# SERVICE BULLETIN

Classification: EC04-013a	Reference: NTB04-124a	Date March 21, 2005
------------------------------	--------------------------	------------------------

## 2004 TITAN AND ARMADA; KNOCKING NOISE FROM ENGINE AREA

This bulletin amends NTB04-124. The Service Procedure and Parts Information have been amended.  
Please discard all paper copies of the earlier version.

Figure 1

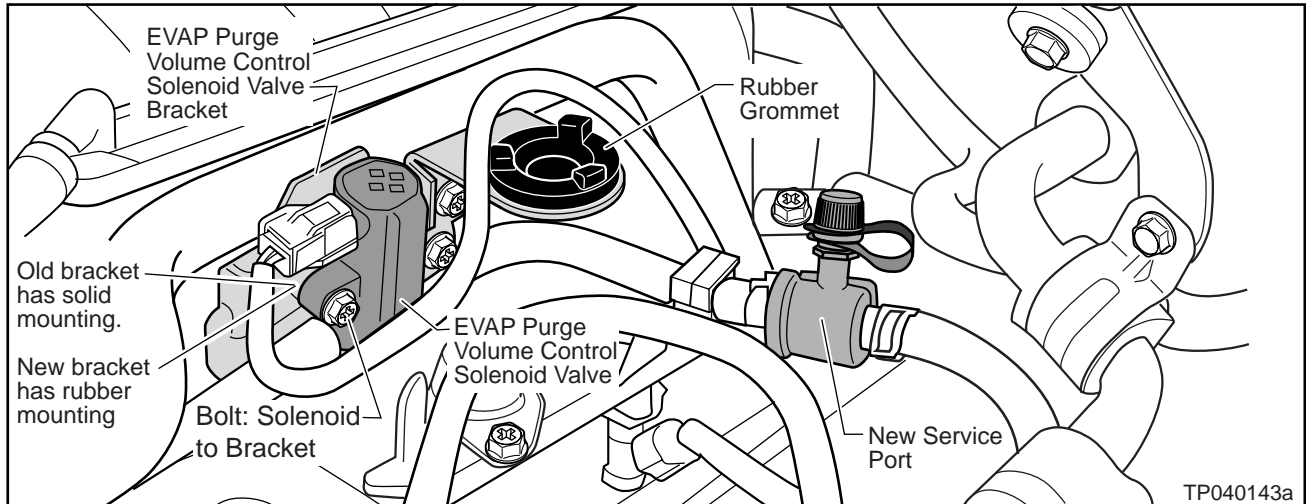
7. Remove the engine cover and replace the following parts (see Figures 1 and 2):

- EVAP canister purge volume control solenoid valve bracket.
- Bolts that hold the solenoid valve to the bracket.
- Service port.

- Use the new parts listed in the Parts Information.
- Make sure you move the rubber grommet and solenoid valve from the old bracket to the new bracket (see Figure 1).
- Make sure you install the Service Port in the correct direction (see Figure 2).

Figure 2

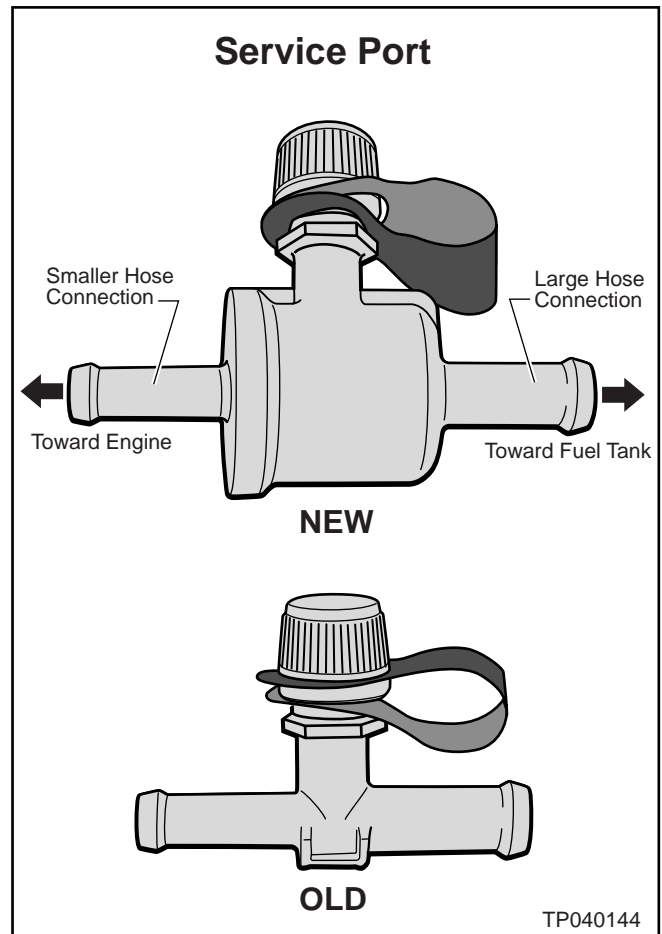
**NOTE:** If your vehicle already has the “new” style service port, this bulletin does not apply (see Figure 2).
